Access Compliance Report

Public Rights-of-Way

Intersection ID: 9982	Main Street: E_36TH_ST	Cross Street: N_DAVIDSON_ST	Location: W
ADA ID: DE10176AC3AE	Ramp Type: PerpDiag	Initial Pass/Fail: Fail	Overall Compliance: No
		Severity Score: 12.5

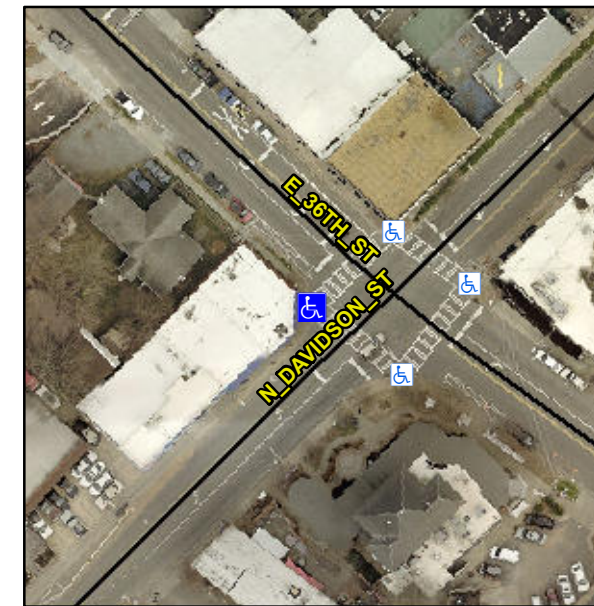
R304.2.2

Compliance	Description	Data	Compliance	Description	Data
N/A	Ramp Length (in)	56.0	No	Ramp Slope (%)	11.1
Yes	Ramp Width (in)	48.0	Yes	Ramp XSlope (%)	1.0
N/A	Flare Type LT	N/A	N/A	Flare Type RT	N/A
N/A	Flare Slope LT (%)	N/A	N/A	Flare Slope RT (%)	N/A
N/A	Flare Traversable LT?	N/A	N/A	Flare Traversable RT?	N/A
N/A	Landing Length (in)	N/A	N/A	DWS Provided?	N/A
N/A	Landing Width (in)	N/A	N/A	DWS Contrast?	N/A
N/A	Landing Slope (%)	N/A	N/A	DWS Length (in)	N/A
N/A	Landing X Slope (%)	N/A	N/A	DWS Full Width?	N/A
N/A	Landing Curb? (Y/N)	N/A	N/A	DWS Offset (in)	N/A
N/A	Shared Landing?	N/A			
N/A	Gutter Ponding?	N/A	N/A	Gutter Slope (%)	N/A
N/A	Gutter Lip Ht (in)	1.0	N/A	Gutter X Slope (%)	N/A
N/A	Painted X Walk1?	Yes	N/A	Painted X Walk2?	Yes
	X Walk 1 Direction	To SE		X Walk 2 Direction	To NE
N/A	X Walk 1 Width (in)	112.0	N/A	X Walk 2 Width (in)	108.0
	X Walk 1 Slope (%)	5.8		X Walk 2 Slope (%)	1.6
	X Walk 1 X Slope (%)	1.5		X Walk 2 X Slope (%)	2.1

Remove & Replace Curb Ramp With Two New Directional Ramps or Equivalent.
